**RE : Minor Project Modification #5 for the Riverside Transmission Reliability Project**

# MINOR PROJECT REFINEMENT REQUEST FORM

## **MPR 05 – RTRP Access Roads and Work Areas**

Southern California Edison (SCE)  
*Riverside Transmission Reliability Project (RTRP)*

**Figure 06 – Modification 10 and Modification 11**

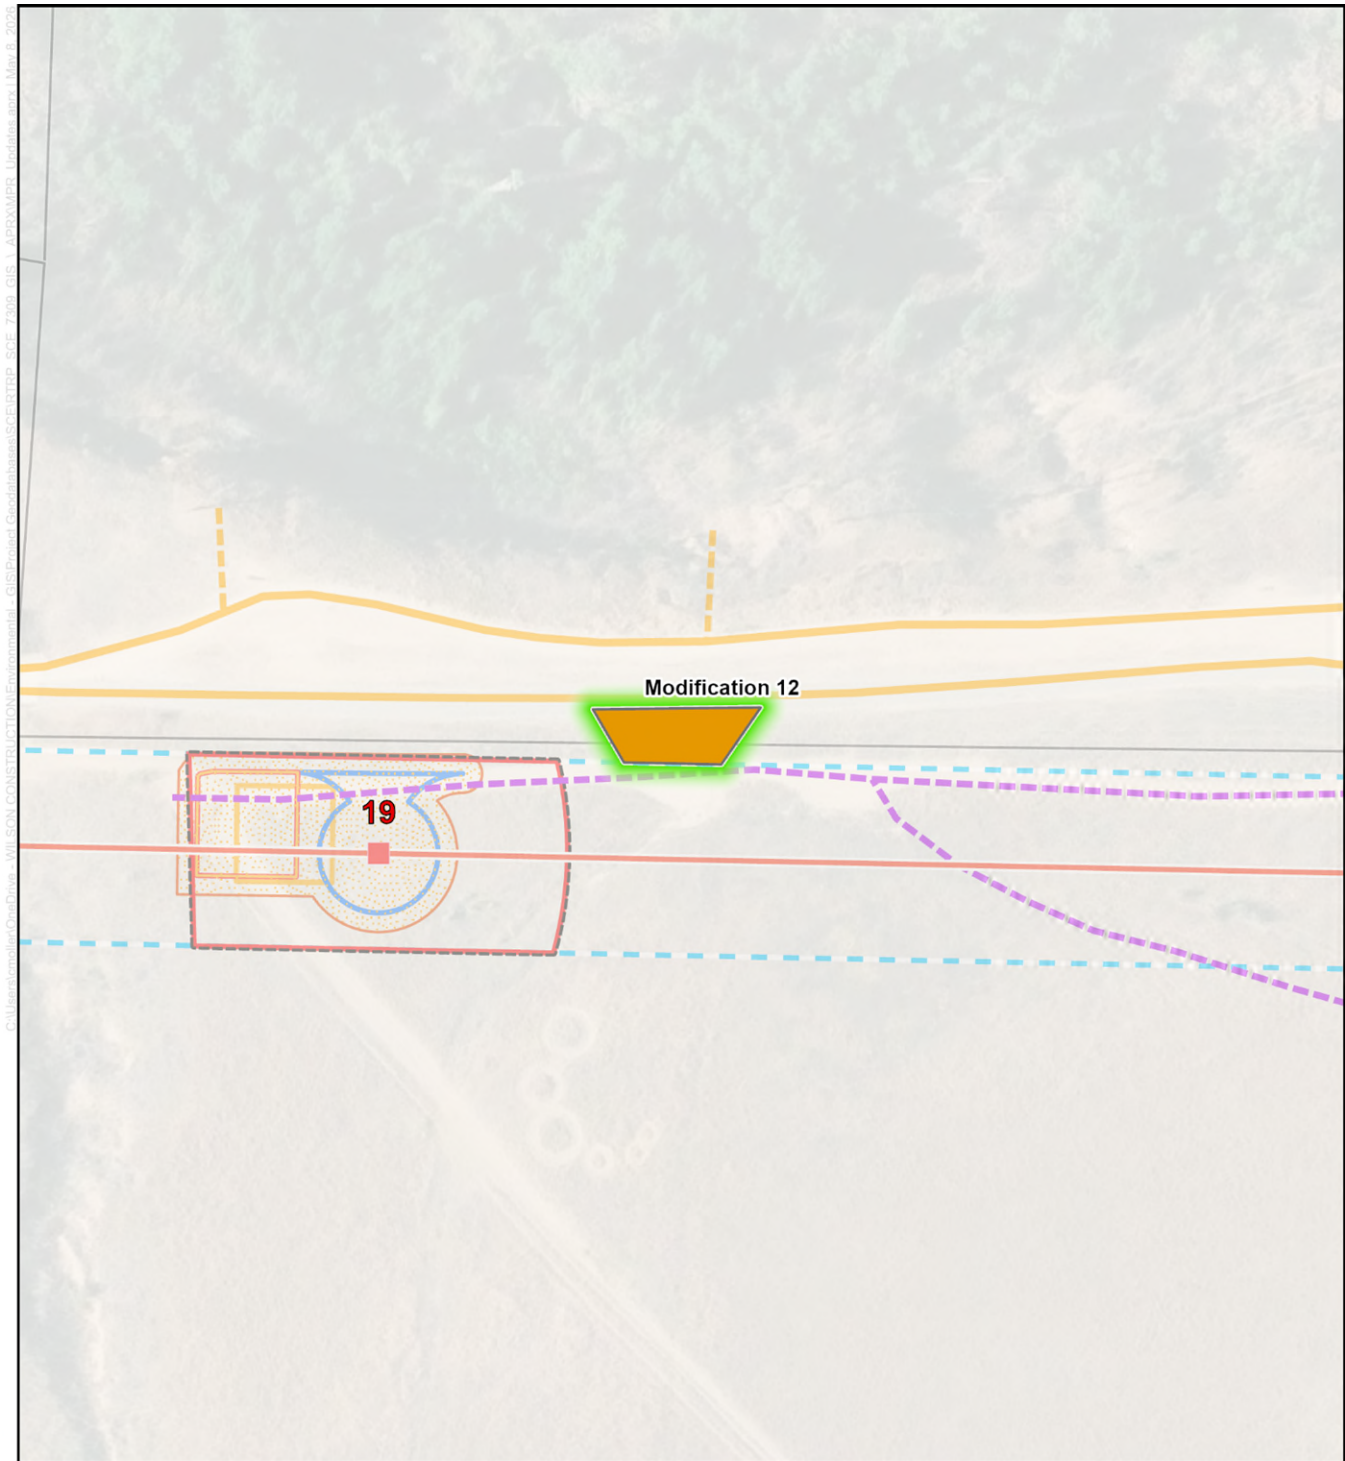
**Modification 10 – Reroute Access Road to/from SART near Const #21 and #22 (Figure 06)**

- Landowner: State of California/Cox II, Henry C/SART
- Land Use: Open space, recreational
- Proposing an existing Edison access road and gate to access Const #21 and #22 work areas and eliminate the previously proposed access road (see Modification 11 below).
- Existing road with no improvements needed.
- Previously approved as TEWS 06 – expires 06/02/2026.

**Modification 11 – Eliminate Access Road to/from SART near Const #21 and #22 (Figure 06)**

- Landowner: State of California/Cox II, Henry C/SART
- Land Use: Open space, recreational
- Proposed elimination of this road as it is blocked by concrete bollards and impassable/unusable. Will be replaced with an existing road (see Modification 10 above).

**Figure 07 – Modification 12**

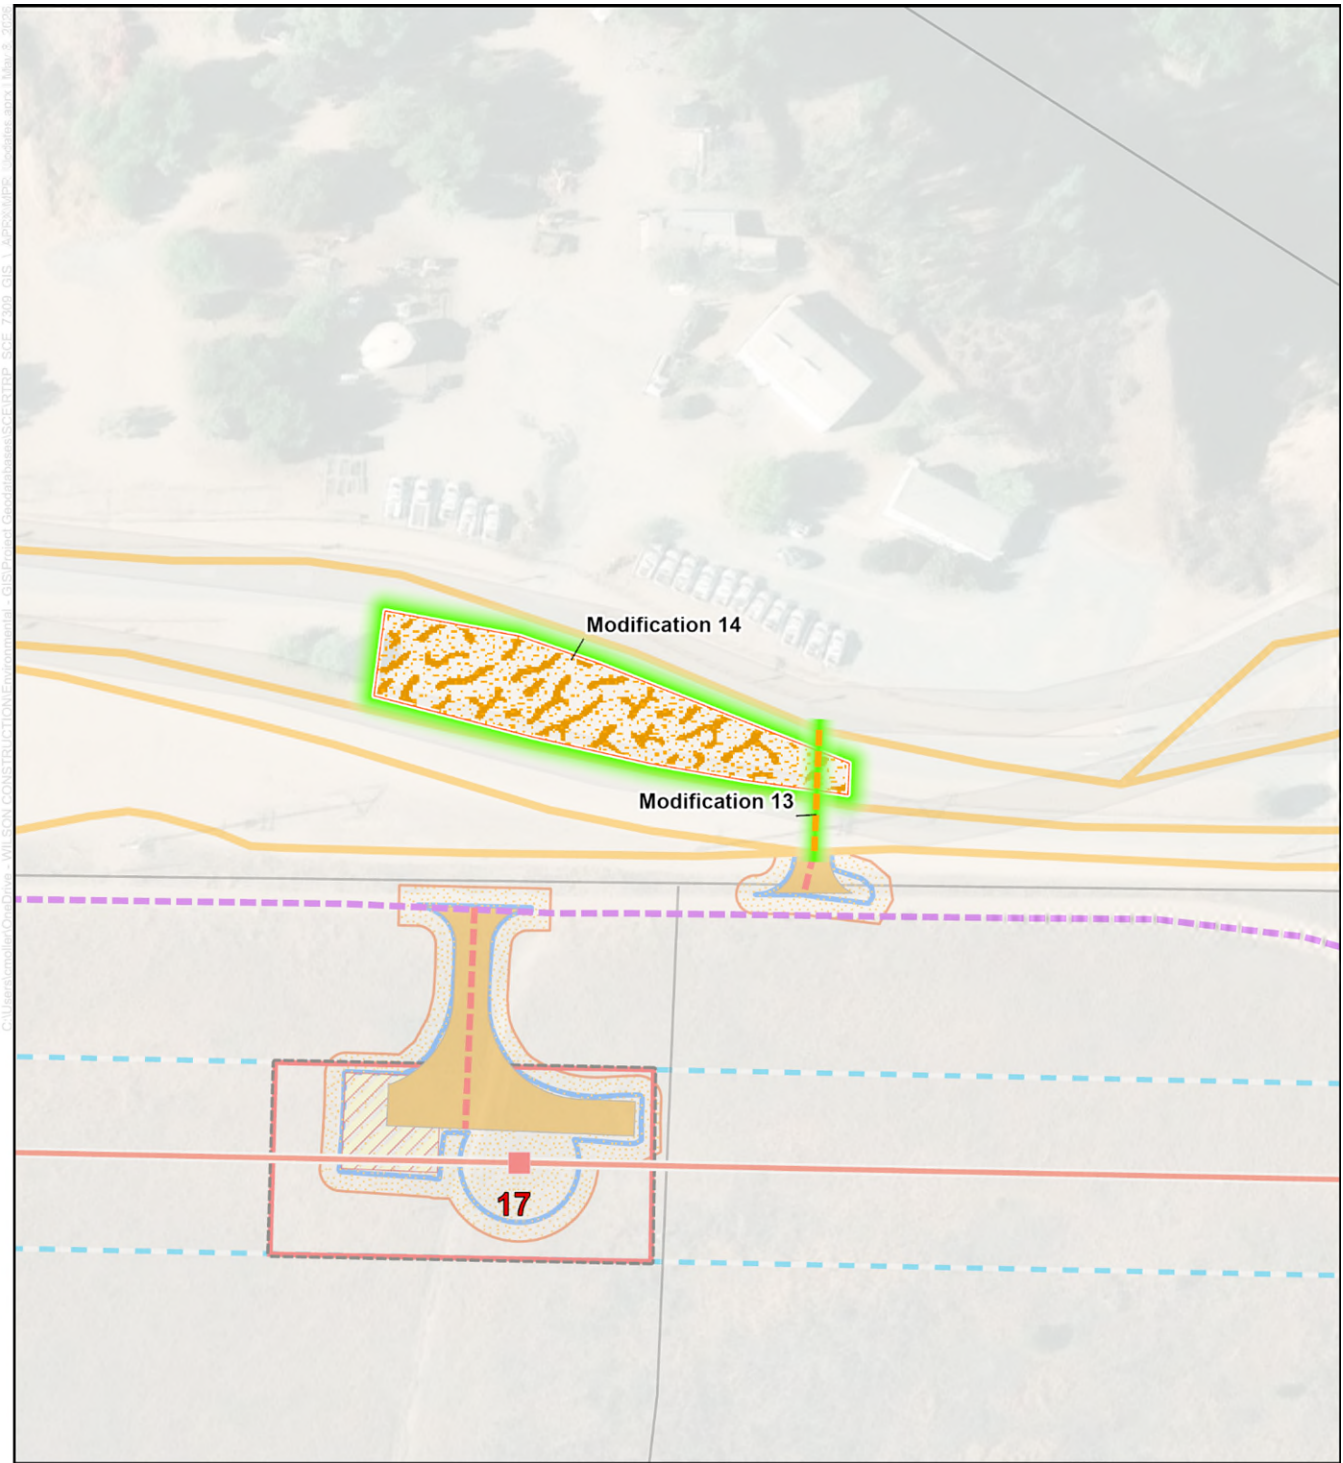
**Modification 12 – Add Temporary Access from SART to Const #19 (Figure 07)**

- Landowner: State of California/Cox II, Henry C/SART
- Land Use: Open space, recreational
- Proposing a new temporary access road from SART to Const #19 to provide improved ingress/egress and eliminate out-and-back travel from Const #22 to Const #19.
- New temporary access road.

**Figure 08 – Modification 13 and Modification 14**

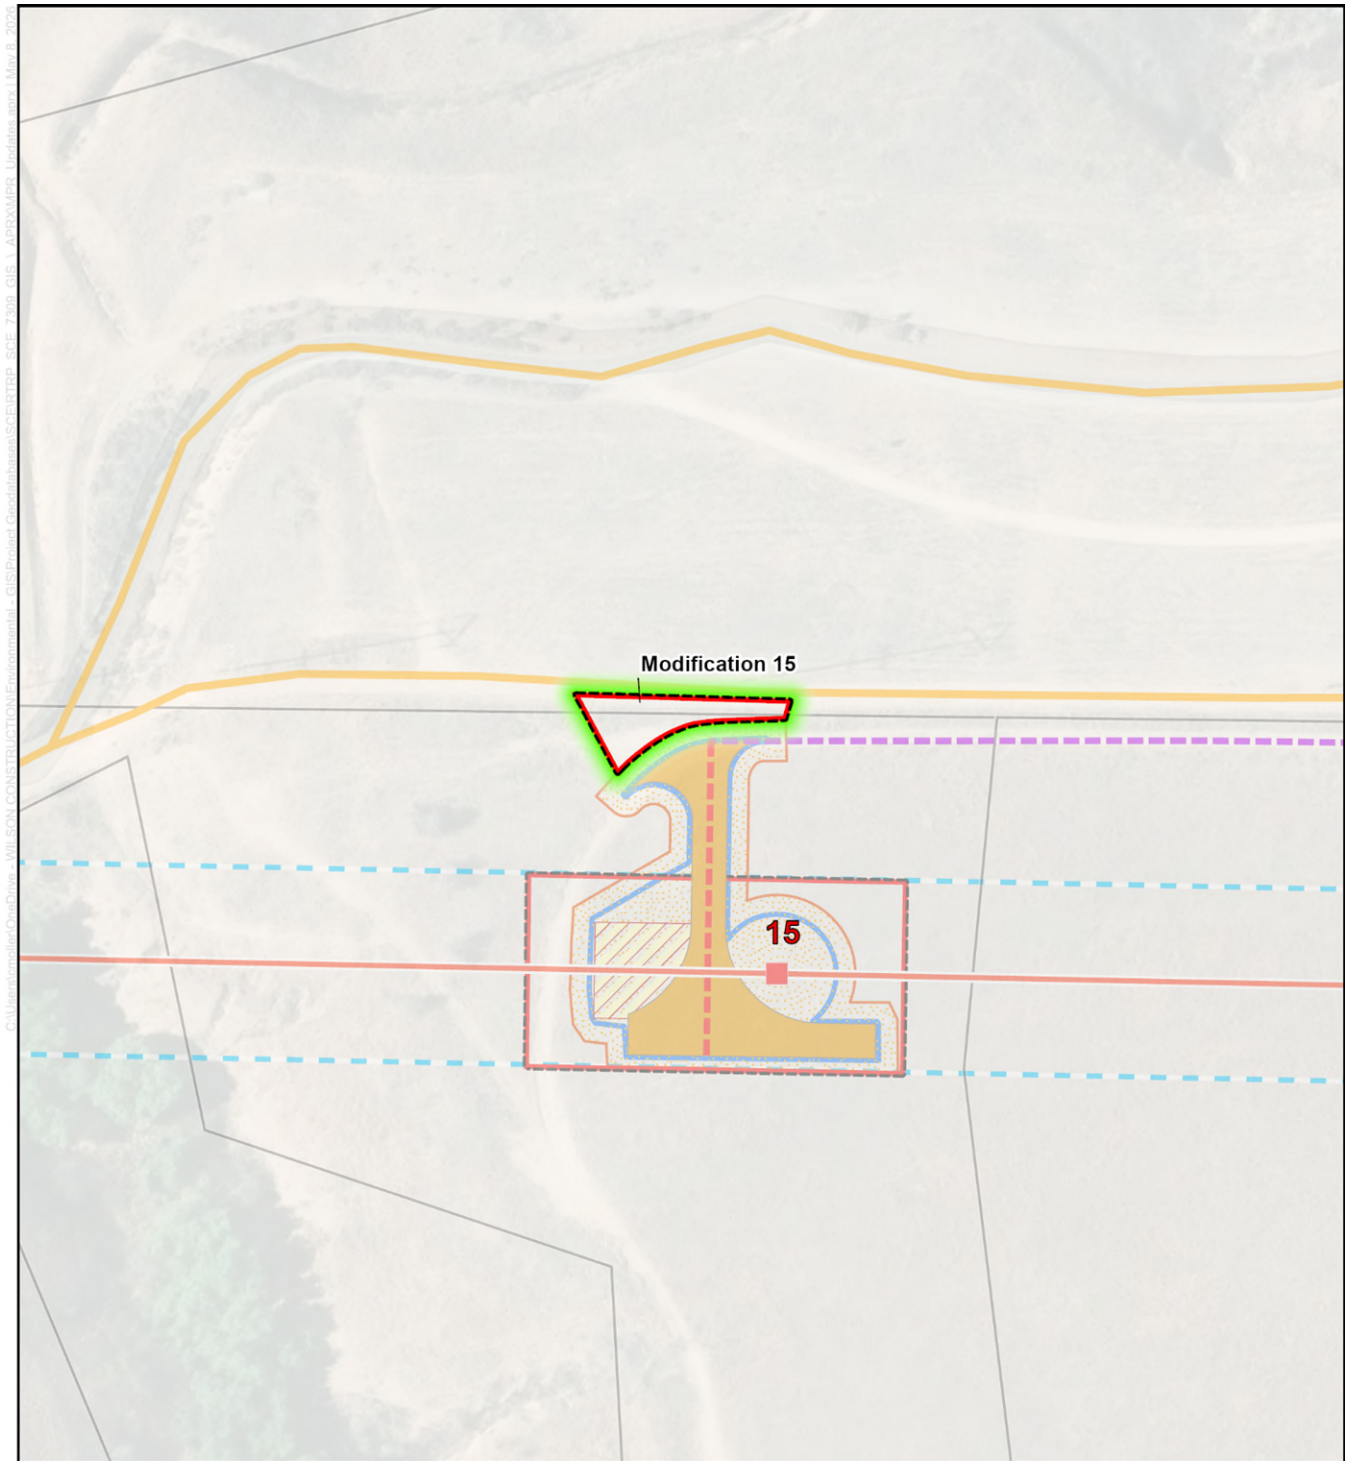
**Modification 13 – Add Temporary Access from Hidden Valley Nature Rd. to Const #17 RTRP Access (Figure 08)**

- Landowner: Riverside County/SART
- Land Use: Open space, recreational
- Proposing a disturbed, existing road/pathway from the Hidden Valley Nature Center Road to connect with Project access on SART. This pathway exists and is currently utilized by the park staff. \*Note – approval of Modification 14 below would include this pathway.
- Existing disturbed access path with no improvement needed.

**Modification 14 – Add Temporary Work Area Near Const #17 (Figure 08)**

- Landowner: Riverside County/SART
- Land Use: Open space, recreational
- Proposing use of an existing disturbed area between Hidden Valley Nature Center Road and the SART for project use, parking, staging etc.
- Existing disturbed area with no improvement needed.
